Case File Number: PLN20124

Location:	1431 Franklin Street
Assessor's Parcel Number(s):	008 062100807
Proposal:	Major Conditional Use Permit and Regular Design Review to construct a 27-story (425-foot tall) 419,480 square feet office tower with a parking garage above grade.
Applicant:	TC II 1431 Franklin, LLC
Contact Person/ Phone Number:	Kyle Winkler, Tidewater Capital/(510) 290-9901
Owner:	TC II 1431 Franklin, LLC
Case File Number:	PLN20124
Planning Permits Required:	Major Conditional Use Permit for large scale development; Regular Design Review
General Plan:	Central Business District
Zoning:	CBD-P Central Business District Pedestrian Retail Commercial Zone Height Area 7, no limit
Environmental Determination:	Determination Pending, Environmental analysis to be conducted prior to any discretionary action
Historic Status:	Project site is located within an existing listed National Register historic resource, the Downtown Historic District Area of Primary Importance (API).

Office Entitlement - Response to Design Review Analysis
11/09/2021

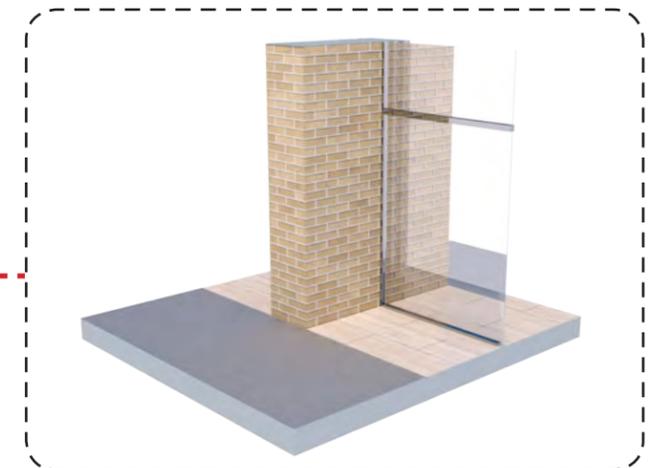
The at-grade building entrance contains a door but does not use projection or recessing of the entrance. There is no discernible change in material and no awning is proposed or other method used to achieve a prominent entrance.

The revised lobby entrance is recessed from the façade by three feet to give the visitor a protected zone against the elements. The façade on the building has been widened to announce the entrance of the building. Signage has been added above the door to clearly announce the entrance and the address of the building. The entrance has been located more central on the building to make the entrance even more obvious. A canopy has been added to the entrance to further announce the entrance.

Glass recessed 3' to provide protected zone

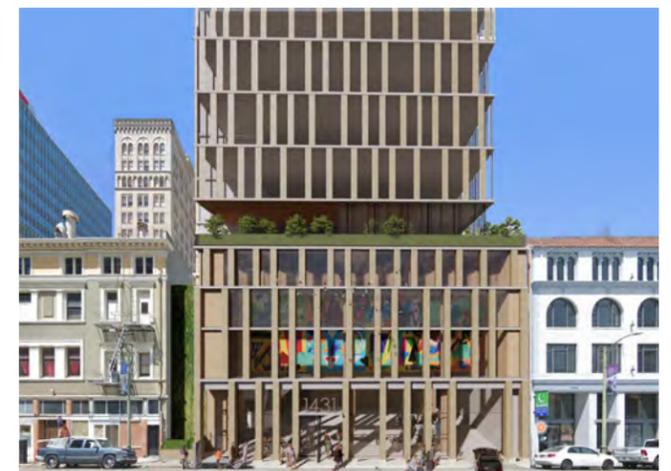
We are not entirely sure with what part of the design the staff is concerned with given no specific concerns were noted in detail. It is also difficult to relate the concern of the proposed design with the API given no specific concern was referenced. The description above of the proposed building is for the most part accurate, but it is not clear what part of the design the staff is concerned with. Is the proposed design disliked, or is the scale of the design unacceptable, or is the defined building pattern not liked?

From there we adjusted the window openings to give the Piano Nobile slightly bigger openings. The difficulty there is that these levels are the parking levels which sets up a difficult problem. We want the windows to be open to the inside, but not have the vehicles visible to the exterior. The light needed to transfer into the building and out at night to give the building a sense of depth. The solution was to have a full height glass wall between the vertical columns of brick.

The proportion of the windows in the Piano Nobile zone have been widened for reasons noted above, but also given a rhythm that is more modulated than randomized. This gives the façade a direct relationship to the adjacent buildings. Moving upward, the zone more commonly referred to as the attic zone, in classical architecture, has a smaller more truncated proportion that relates both to Classical architecture, but also the adjacent buildings. The windows have been reduced in size and a cornice line has been introduced. We have also set the area above the attic zone back by ten feet and created a roof garden at that level to reinforce the podium datum that follows all along Franklin.

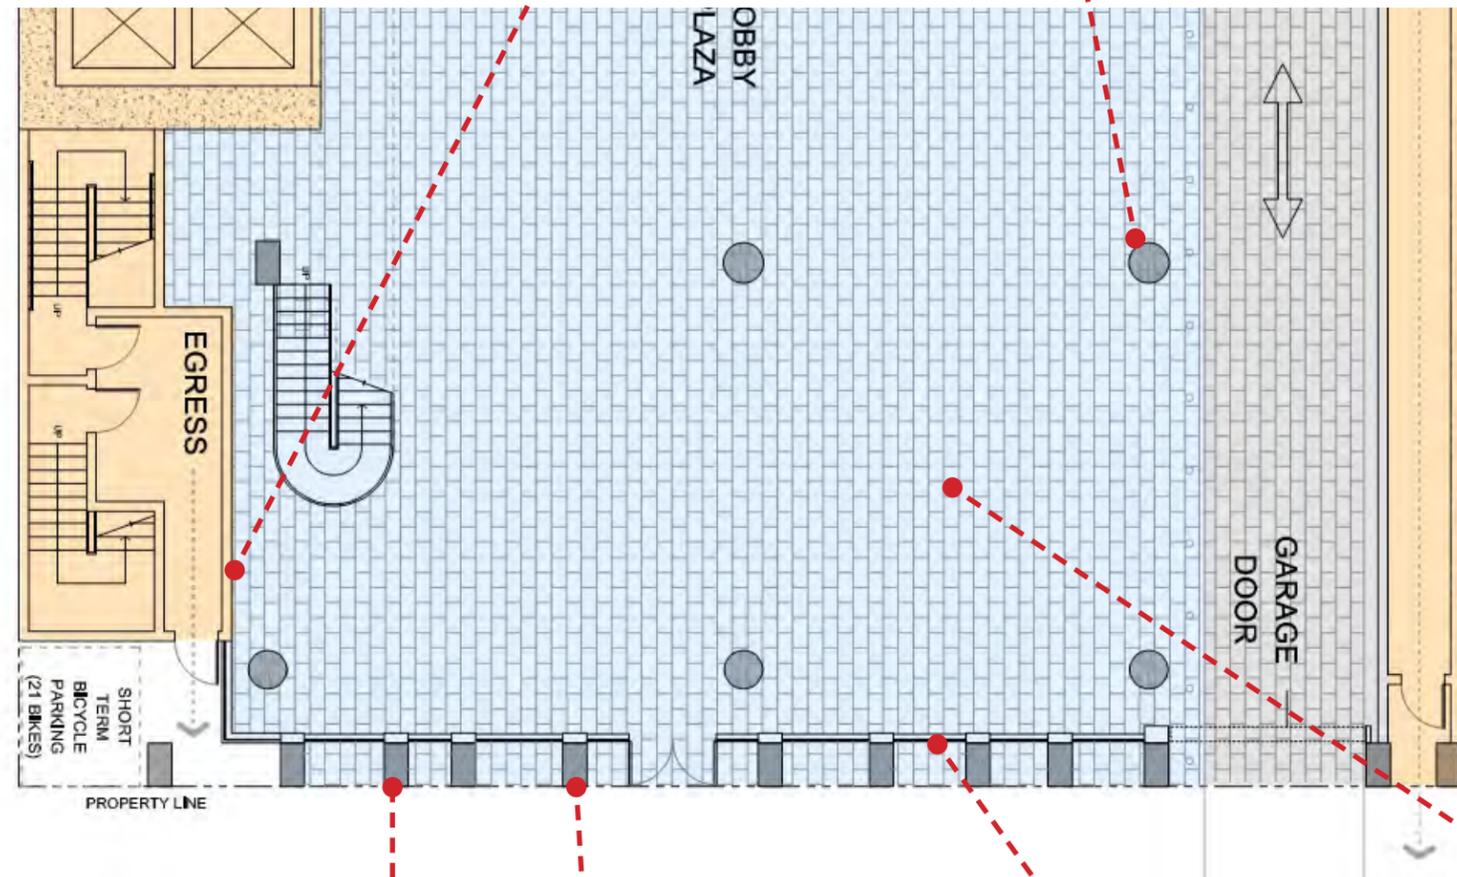
The plans provide general not specific dimensions for the lobby. More information on the columns/pillars, materials of design, proposed activity (if any) would be located at the ground level.

The proposed design is for an office building, not a commercial space. This does not seem to apply to our project. Below is a plan showing the specifics of the lobby and the finishes.

Upper void amenity space

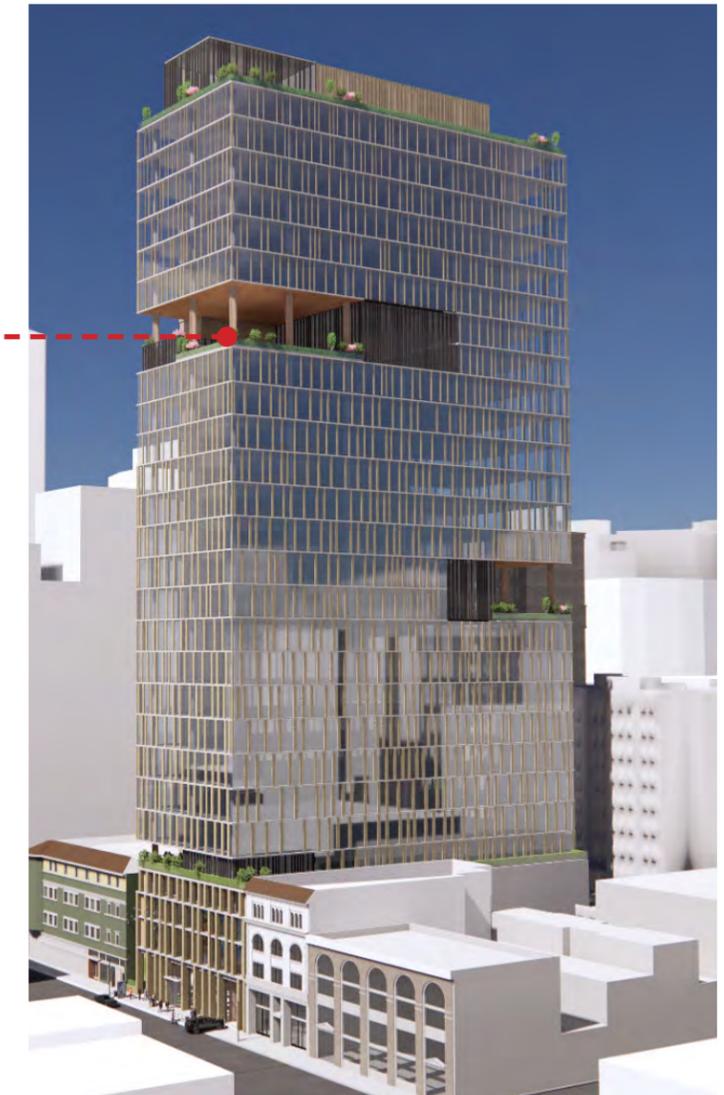
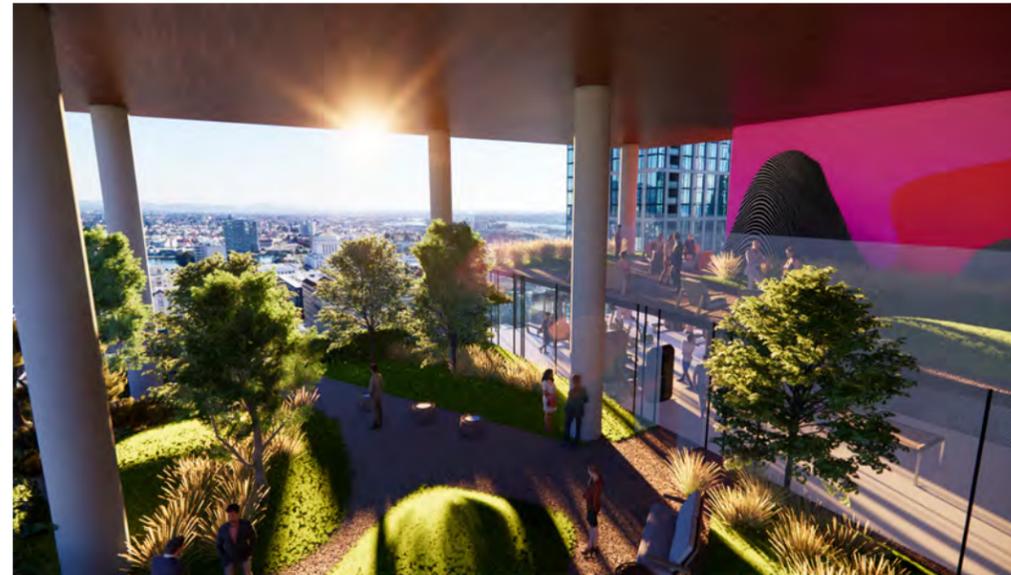
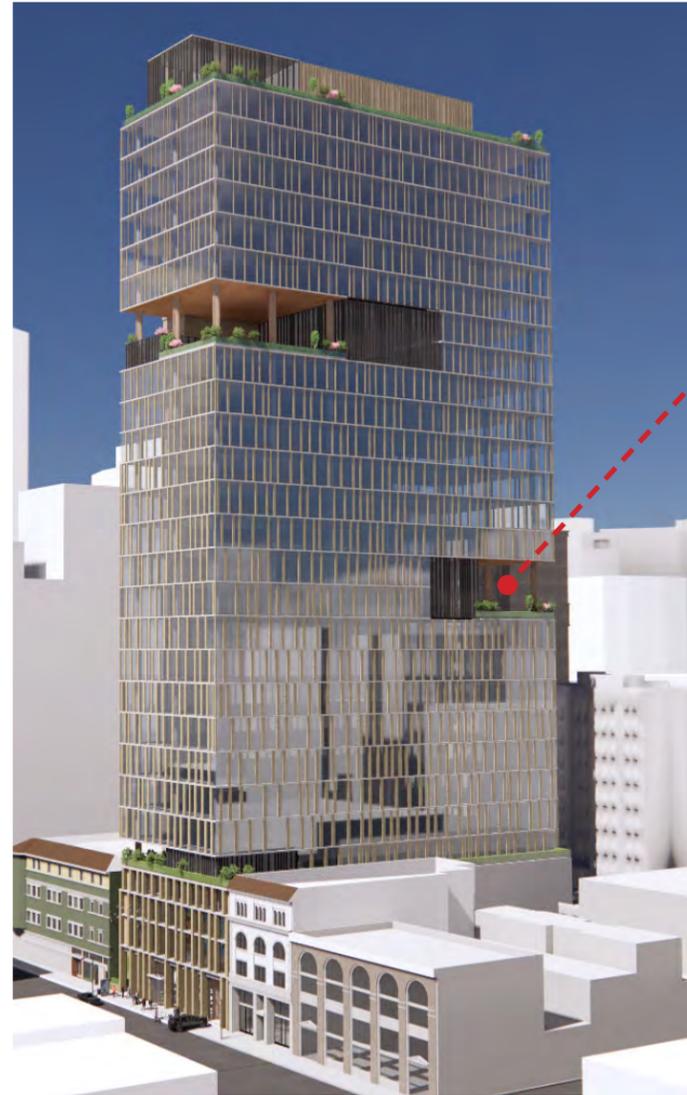
More information is required on composition and materials of the outdoor and indoor amenities and the "carved" amenity voids."

The amenity floors are expressed as subtractions from the overall massing of the building, which are placed at strategic locations to allow for views and a unified sense of composition over the faces of the tower. A variety of outdoor and indoor spaces on the amenity floors will be enhanced with landscape and materials that tie into the high quality experience of the building as a whole.

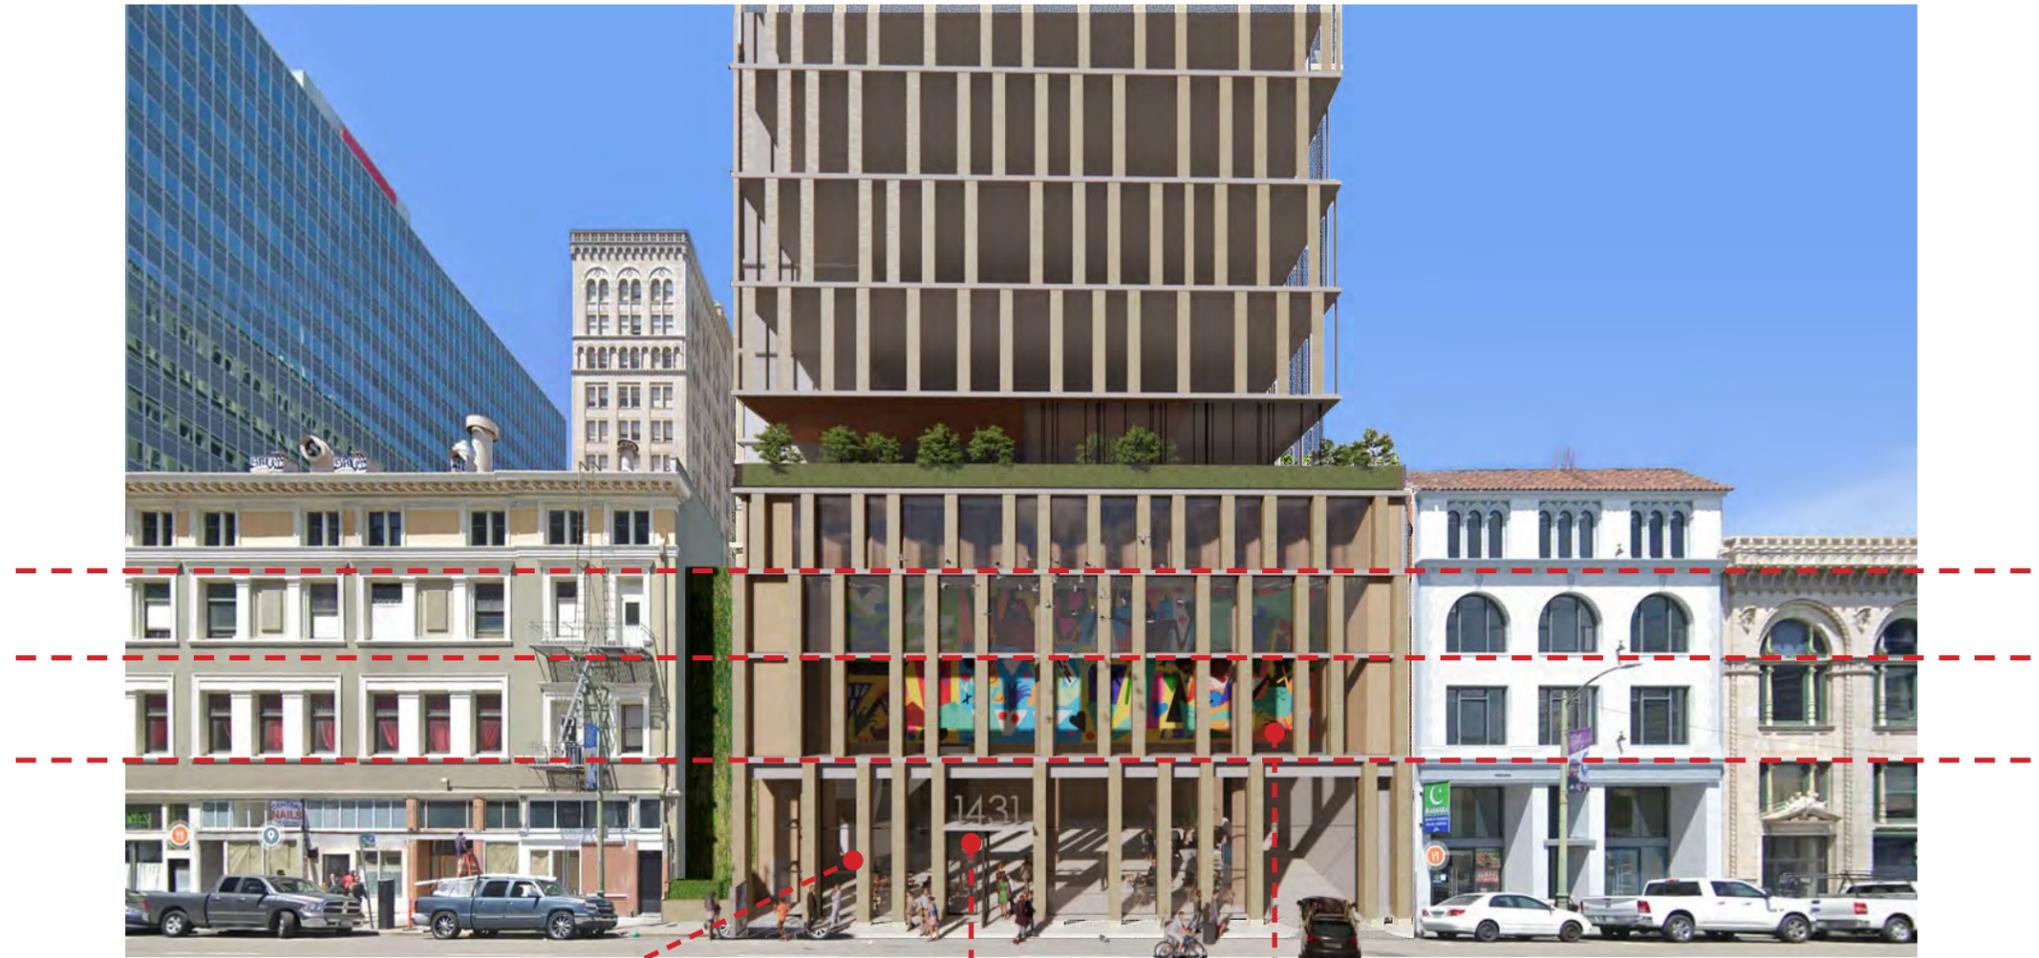
The height of the floor levels of the base relate to the horizontal details of the adjacent buildings, but box design of the building and the “gradient pattern” with wider glazed windows and wide columns at ground level is in contrast to buildings in the API. Staff is concerned with the challenge of maintaining high quality materials for the proposed fenestration and an adverse effect on the API.

The revised design has adjusted the floor levels of the base to relate to the horizontal details of the adjacent buildings. The windows at the base have been widened to open up the lobby and to coordinate with the adjacent buildings and the API.

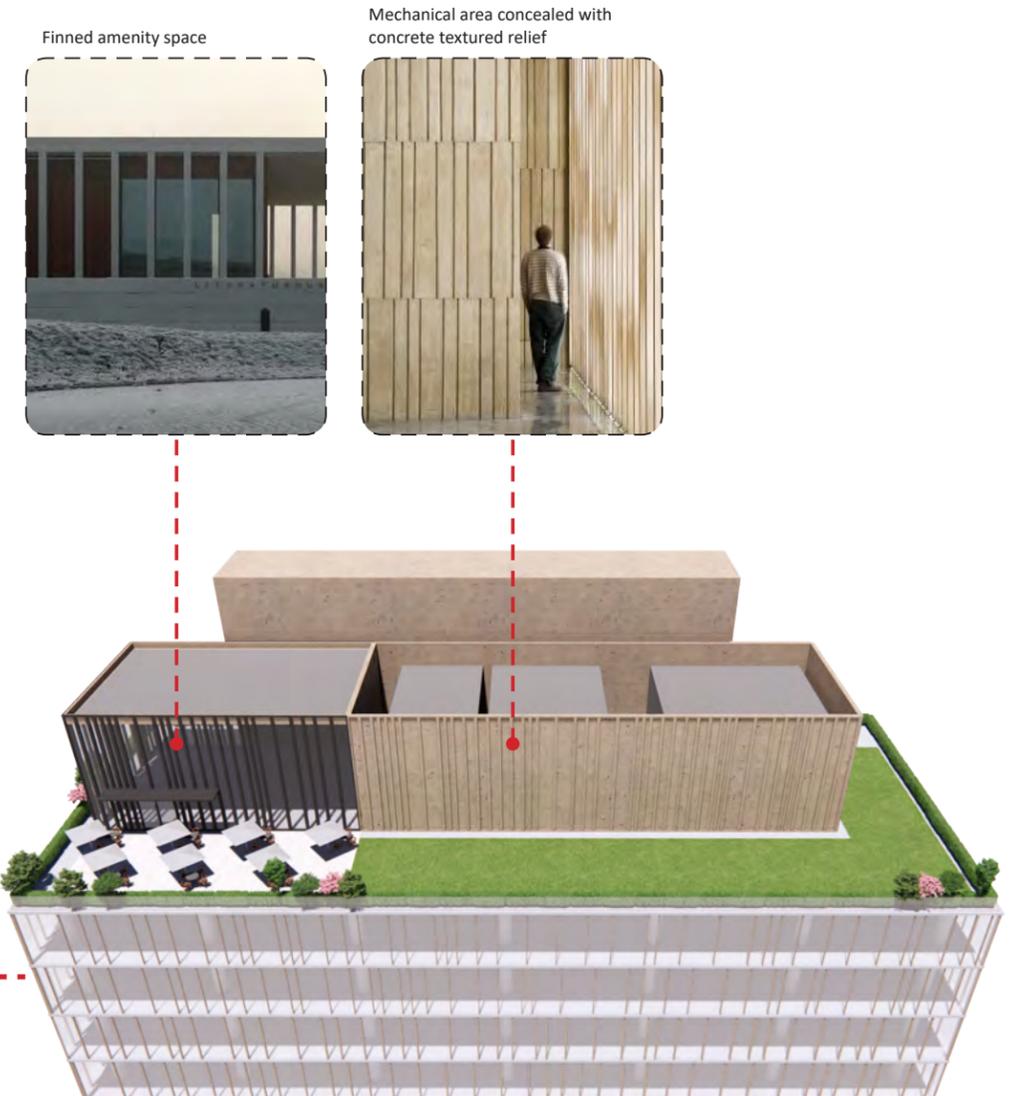
The proposed green space concept on the roof does not supply details on proposed materials, roof line decoration or design, or floor plan.

Section 5.4.2 continues to on to say, 'Rooflines should have shapes, materials, and colors that relate to the rest of the building, while still being differentiated to achieve an upper terminus.' Though I understand where this logic comes from, I would also note that in the Oakland guidelines they go on to say, 'In general, each applicable guideline should be met to approve a development proposal. However, this document is not intended to restrict innovation, imagination and variety in design.' Providing a roofline that differentiates to achieve an upper terminus really applies to a mid-century modern highrise but not necessarily to all buildings of today. Which is why our solution for the proposed project is based more in a non-classical building terminus. In other words, instead of the building having a cornice or capital like a classical column the design of many buildings today are pattern or volume oriented. In fact, some almost do the opposite, with the top fading away to less than what it was. Below are a couple examples of both directions. That is not to say a building with a cornice is the wrong direction, we are simply noting that the guideline stated here is a recommendation that should be viewed as one option.
